Amendments to the Drawings

REMARKS

Annotated
Marked-up Drawing

FIG. 2

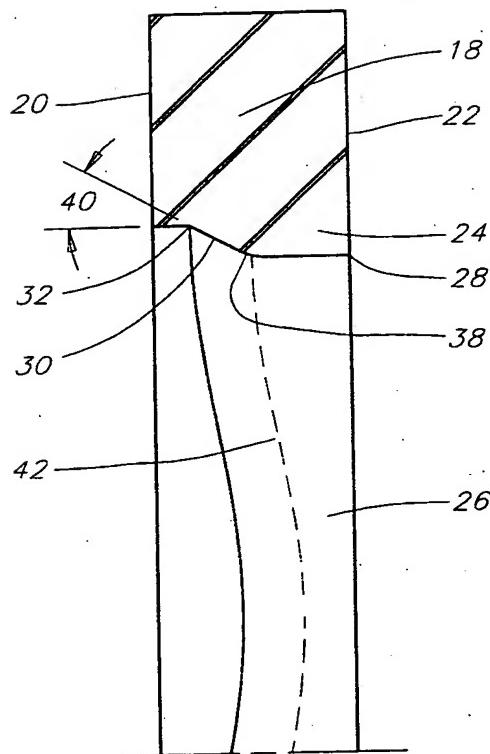
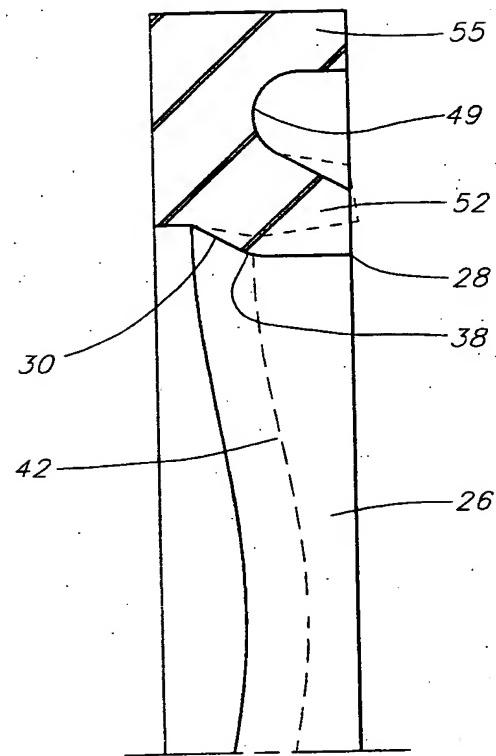
Added reference number 122 to indicate the lubricant chamber (See Appln, amended paragraph 58) and designation of the hydrodynamic wedging angle 158.

The drawings are objected to under 37 CFR 1.83(a) because the claimed features of the sealed partition, lubricant chamber, and hydrodynamic wedging angle must be shown in the drawings or canceled from the claims.

Applicants have amended drawing sheet 1 to accurately correspond to the specification. Fig. 1 has been amended to include reference number 122 for the lubricant chamber and designation of the hydrodynamic wedging angle 158. Applicant submits a marked-up copy of drawing sheet 1 labeled as “Annotated Marked-up Drawing” and a replacement sheet labeled as “Replacement Sheet.” Applicant submits that no new matter has been introduced.
